Work Order ID 99875

Item Name: Crosstube, Fwd High

<b>DART AEROSPACE LTD</b>	<b>Work Order:</b>	99875
<b>Description:</b> Crosstube High Fwd (205/212/412)	<b>Part Number:</b>	D212-664-101
<b>Inspection Dwg:</b> D212-664-141 <b>Rev:</b> D		<b>Page 1 of 1</b>

DRAWING NO. D212-664-141	TITLE XTUBE ASSY (205/212/412 HI FWD)	REV. D	DART AEROSPACE LTD ENGINEERING ORDER		D.E.O. NO. D212-664-141-D-1	SHEET NO. SHEET 1 OF 2	SCALE NTS
DRAWN	CHECKED	OP	MFG. APPR.	APPROVED	MAP	DE APPR.	
DATE 11.04.07	DATE 11.04.11		DATE 11.04.12	DATE 11/04/12		DATE 11.04.12

**D212-664-141/-141B**  
**ASSEMBLY DETAIL**

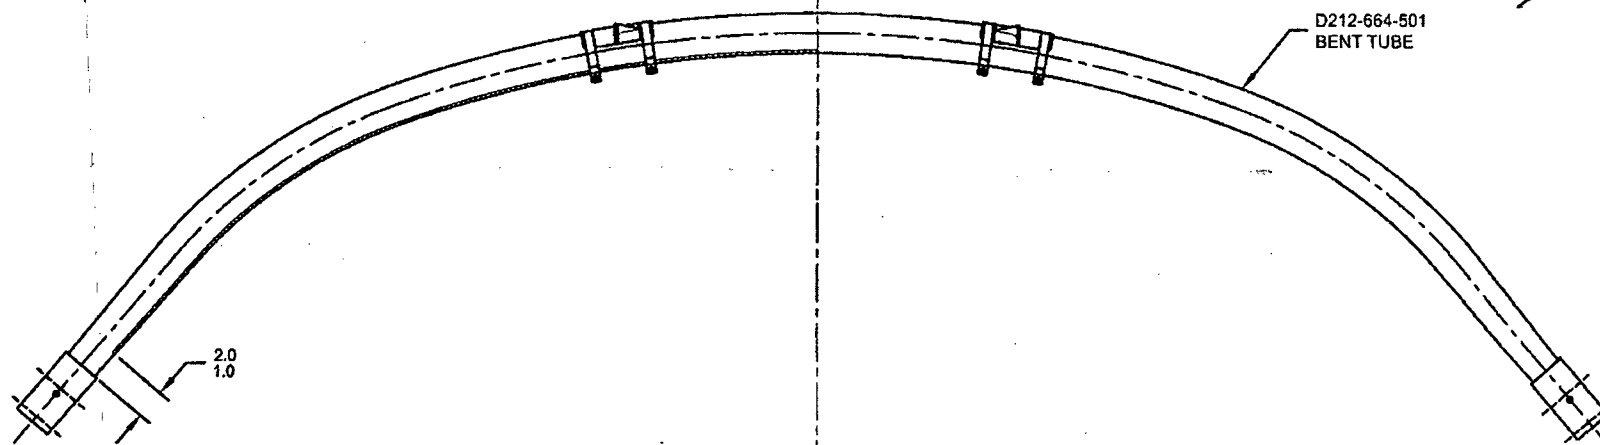
**PURPOSE:**

ADD AN INSPECTION WINDOW TO UNDERSIDE OF CROSSTUBE.

NOTES 2 OF SHEET 1 IS AMENDED AS FOLLOWS:

- 2) FINISH: CHEMICAL CONVERSION COAT PER DART QSI 005 4.1  
PRIME INSIDE AND OUTSIDE PER DART QSI 005 4.2  
MASK UNDERSIDE OF CROSSTUBE AS SHOWN (HATCHED AREA) AND  
PAINT OUTSIDE PER DART QSI 005 4.2  
REMOVE MASKING AND APPLY CLEAR COAT

- 2) FINISH: CHEMICAL CONVERSION COAT PER DART QSI 005 4.1  
PRIME INSIDE AND OUTSIDE PER DART QSI 005 4.2  
PAINT OUTSIDE PER DART QSI 005 4.2

MASK AREA PRIOR TO PAINTING,  
REMOVE MASKING AFTER PAINT  
AND APPLY CLEAR COAT
